ADDENDUM No. 1

BELLEVUE STATE PARK
VAULT RESTROOM BUILDING REPLACEMENT
JACKSON COUNTY, IOWA
PROJECT NUMBER: 14-06-49-01

March 17, 2017

1 FLOOR PLAN

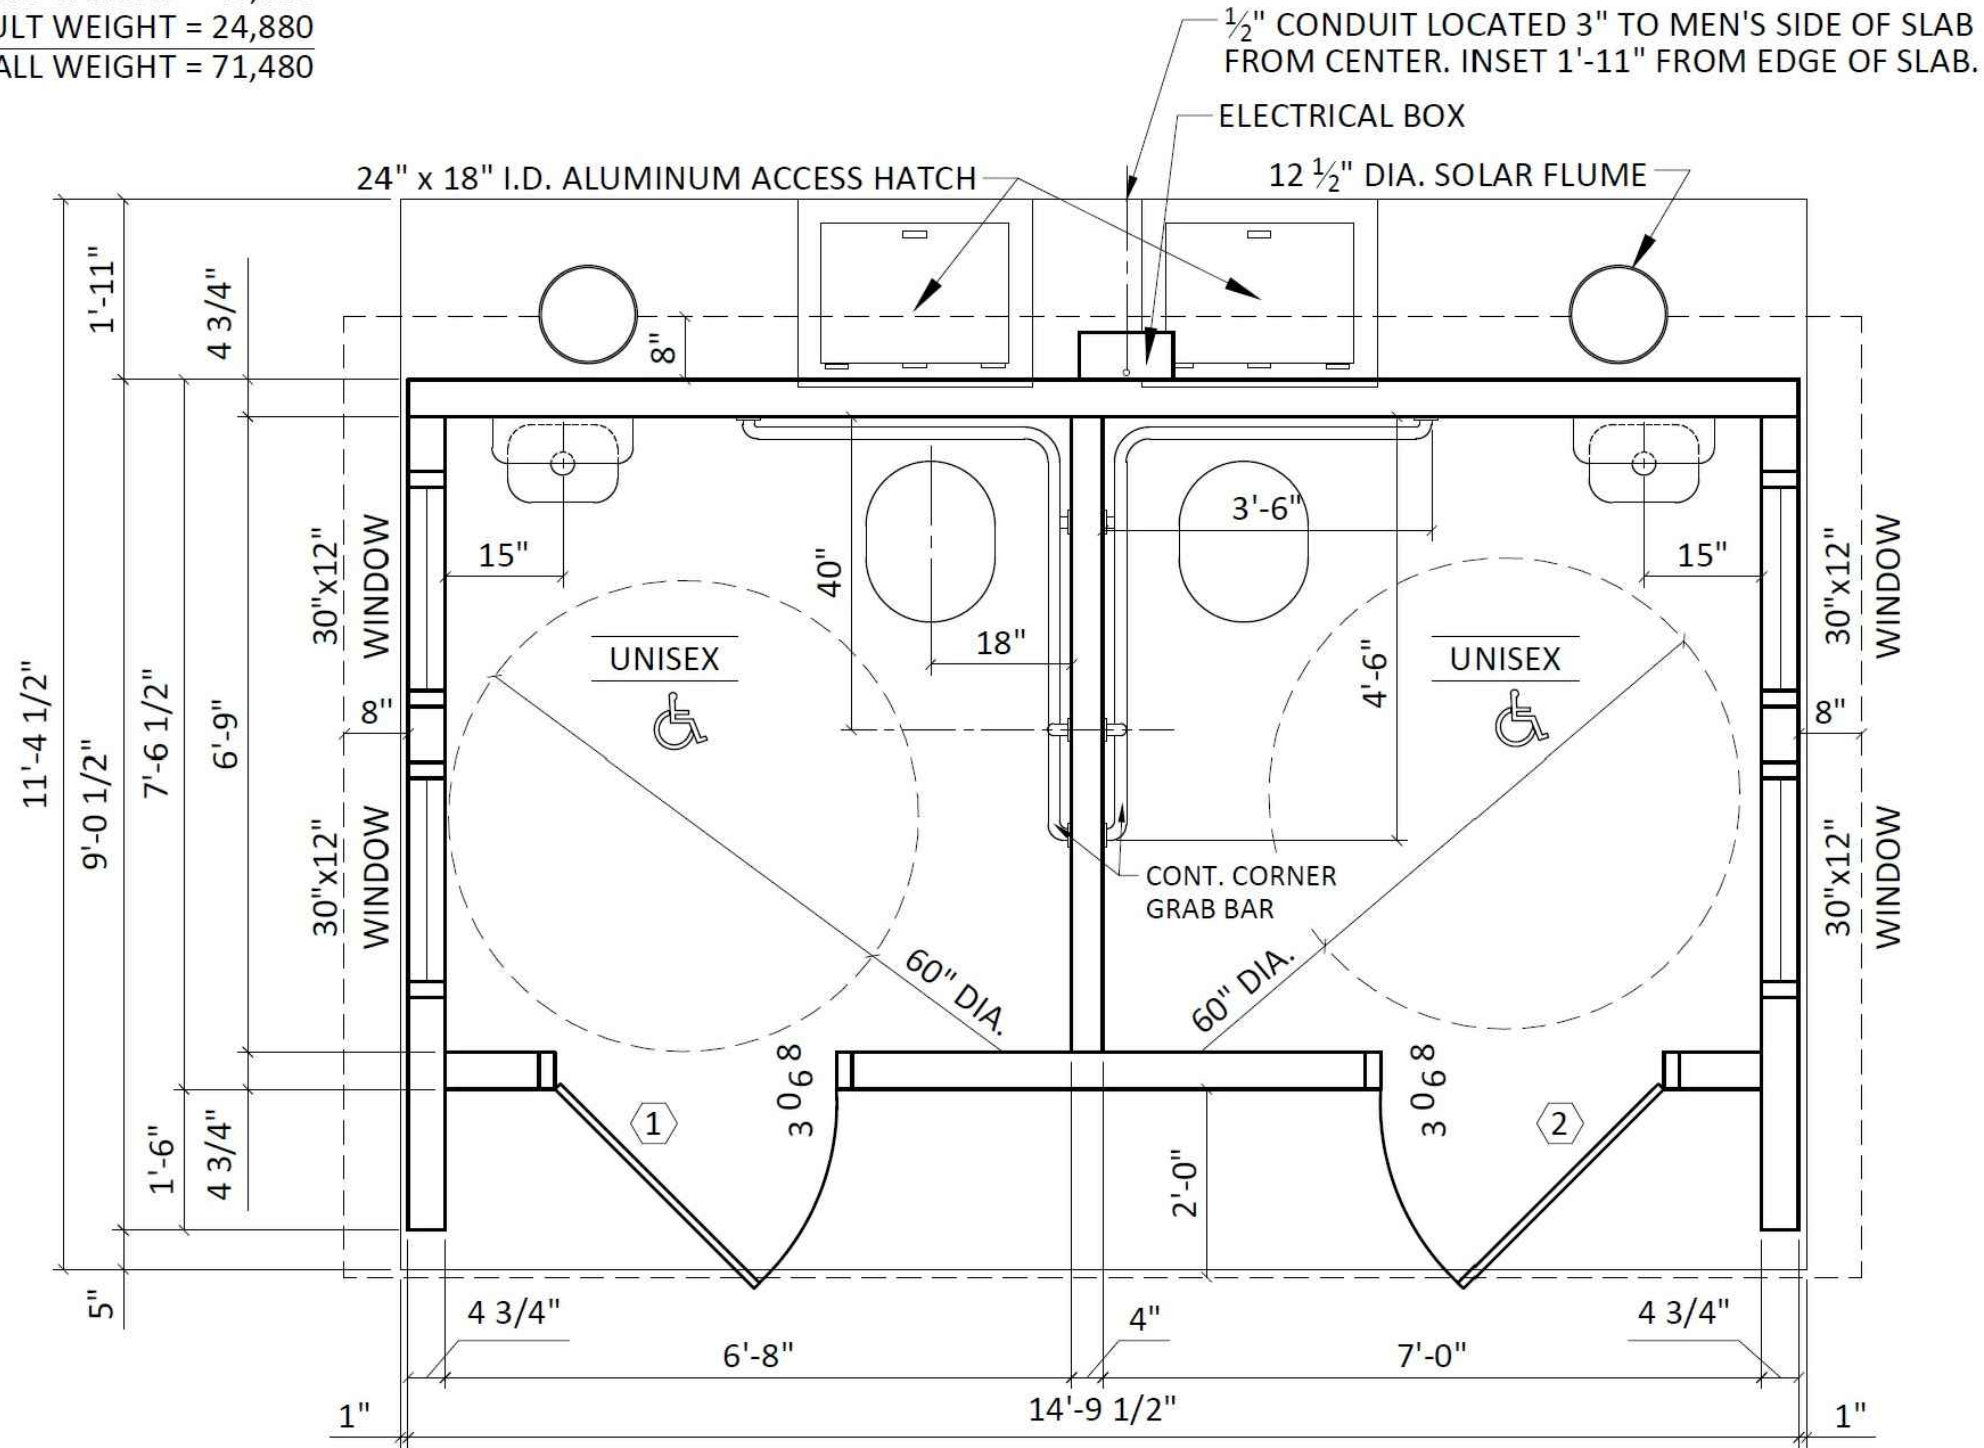
A. Replace Sheet #10 with the attached revised Sheet #10 reflecting the plan view for the Huffcutt Double Vault Unisex Restroom Building.
